# Facility: Stephens Lakes Park

Address: 2001 E. Broadway      Date of Survey: 05/06/10

Photo 9

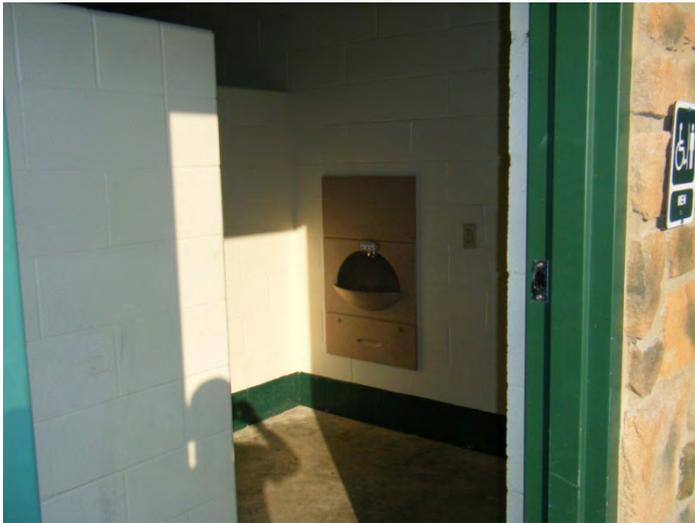
- Refer to site plan included with this report: (M) Existing lavatory in the Men's and Women's Restroom is recessed into wall (see photo 9 on below) and does not meet ADAAG 4.19 requirements for knee space below the lavatory. Options are to remove existing recessed lavatory unit and replace with a new wall-mounted lavatory that meets ADAAG 4.19 or modify the existing lavatories to obtain required knee space below the lavatories (see photo 10 below for example) or leave existing recessed lavatories in place and install an additional wall-hung accessible lavatory next to the existing lavatories. **Estimated Cost: \$3,618.00**
